Results of LMSC Ballot on Draft Standard 802.11 D5.0 - Comments on clauses 0-5 and general comments

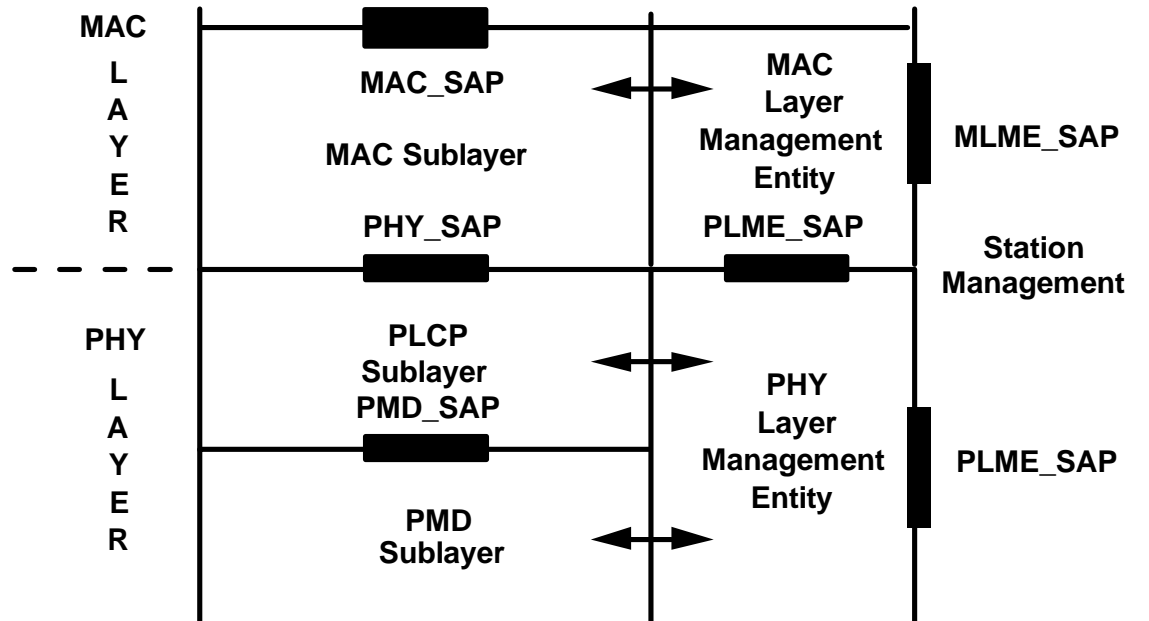
5.8	JD	e		it is distracting to have two PLME_SAP (even though they have the same function) <u>suggest</u> using their full names	See figure at the end
